## CORRECTION OF SERVICE MANUAL

Date: Dec.24,2004 No.: SCH04020 (1/3)

**Please correct your service manual**

Refer to RRV2772 page:118

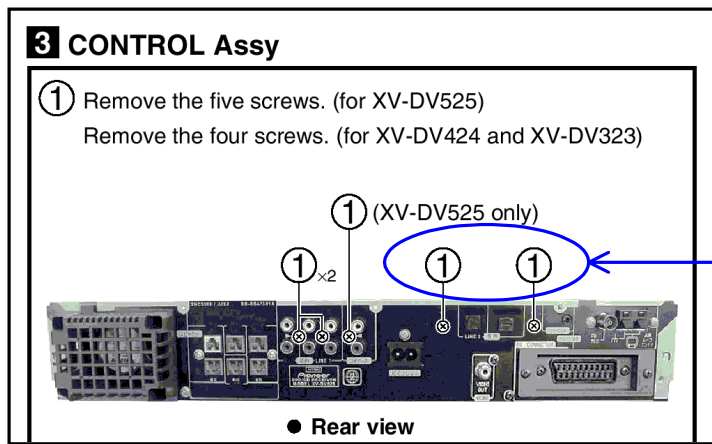
#1) Please add the following contents.

Make sure to tighten the 2 screws when assemble the unit because the DSP assy on the CONTROL assy gets the GND from the rear panel.
